## Detailed Site Plan The Commons at Addison Road Metro

**DSP-06001-03**

SUBJECT:       Detailed Site Plan DSP-06001-03  
                  Type 2 Tree Conservation Plan TCP2-013-2019  
                  The Commons at Addison Road Metro

***Figure 1: Examples of Proposed mural and public art***

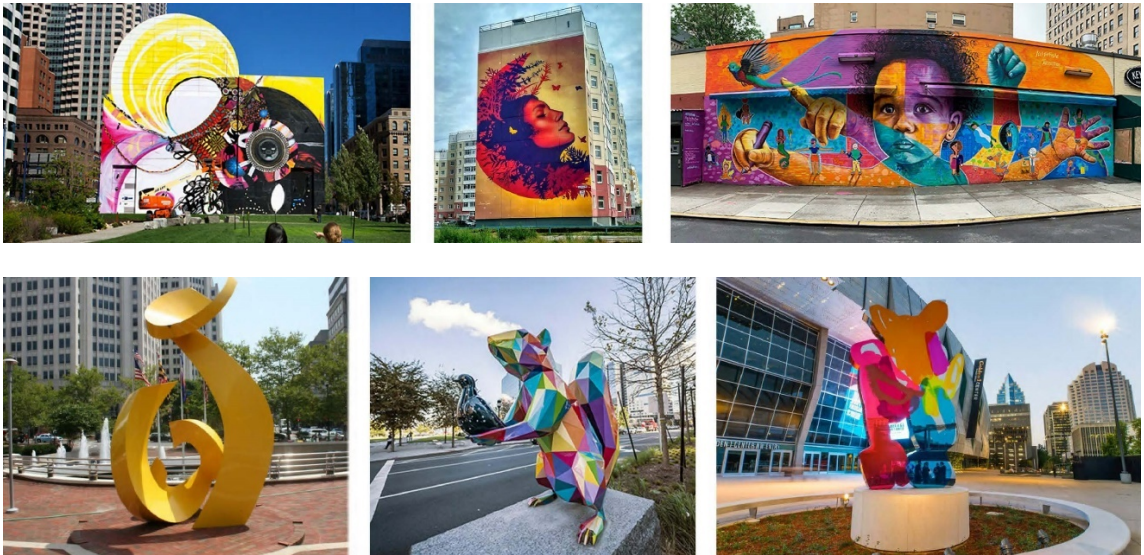
The western plaza proposes a passive recreation space and landscape area that is screened from MD 214 by a 7-foot-high, decorative wood wall for privacy and to mitigate the noise from the roadway. Staff recommends that the height of this fence be reduced to a maximum of 5 feet to improve the scale of the plaza, as conditioned herein.

- j. Reduce the height of the decorative wood fence surrounding the westernmost plaza, north of the building, to a maximum of 5 feet high.
- k. Provide a fire department connection within 200 feet of the front and sides of the building that is visible from the street.

**Figure 3: Proposed Freestanding Sign**

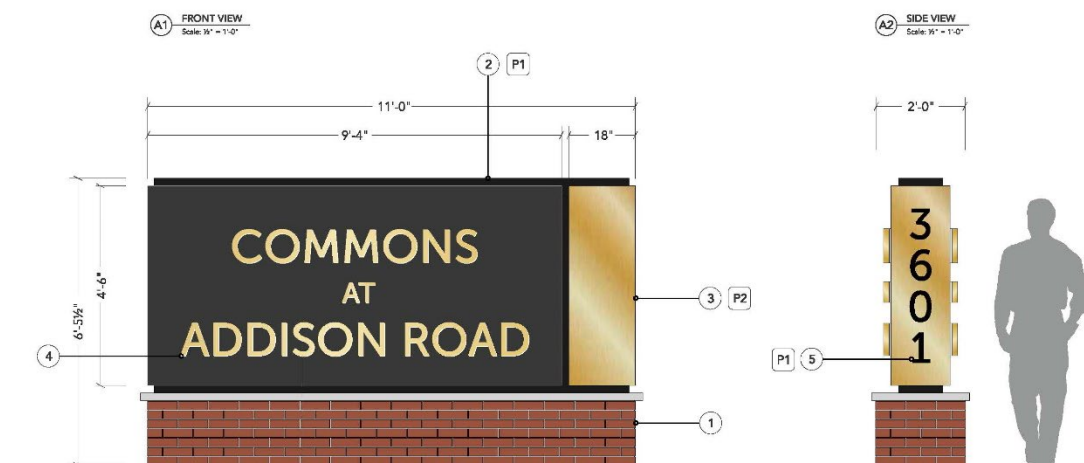
One six-foot-tall, double-faced, freestanding sign is proposed along Addison Road, near the entrance to the site. The sign is constructed of aluminum and mounted on a brick veneer base. The sign includes back-lit, gold leaf lettering on a black background. The 11-foot-wide sign includes landscaping at its base for seasonal interest and has been found acceptable, with the exception of the illumination, which is not allowed by the D-D-O Zone; however, an amendment to allow the sign's illumination is recommended for approval.
